REMARKS/ARGUMENTS

Appl. No. 09/696,358
Amdt. Dated July 23, 2003
Reply to Office action of April 24, 2003

FIG.3A

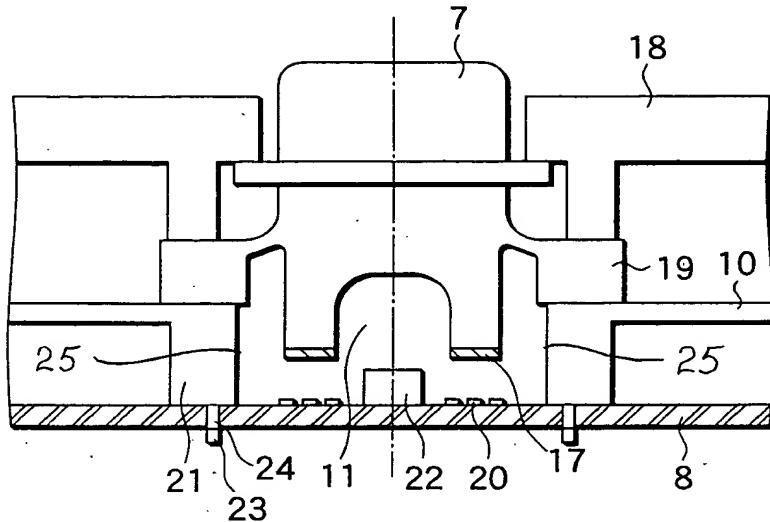
With regard to the objection to the drawings for failing to show "plating (mirror finish) 25" as described in the specification, applicants propose amending Figures 3A, 3B, and 3C to include the identification numeral "25" as shown in red ink in the enclosed copies to identify plating. The

Examiner's approval of the proposed drawing change is requested.
